Addendum 03

To: Wright Ryan Construction (Construction Manager)
From: Ben Walter, CWS Architects
Regarding: **Elm Terrace** – Portland, Maine
Subject: **Addendum 03**

Modify the previously issued documents dated September 8, 2011 and any previously issued addenda, if applicable, as follows:

SECTION 3
3/4"=1'-0" S1.2

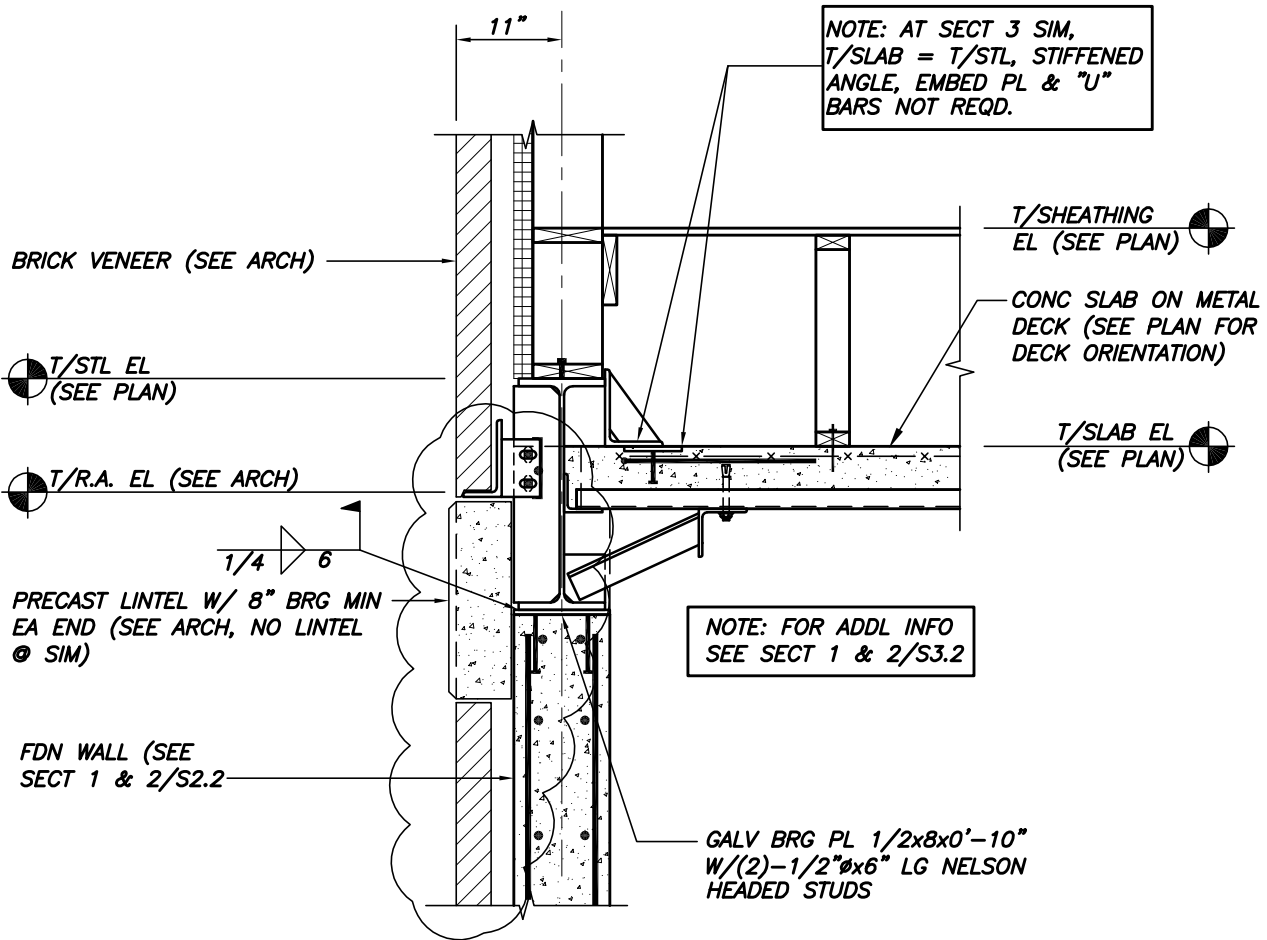
7. Replace detail 2 on Drawing S3.2 with the attached SKS-1-1.
8. Replace detail 3 on Drawing S3.2 with the attached SKS-1-2.
9. Provide square concrete column wraps (not round as indicated on Drawing S1.1) at all six (6) steel columns in the enclosed parking garage area [PARKING GARAGE - 001] per attached SKS-1-3.
10. At all continuous bearing floor trusses to be installed directly over the first floor concrete slab subfloor structure of the building addition wing, a) MSR lumber ratings are not required; and b) the bottom plate of the trusses shall be pressure treated.
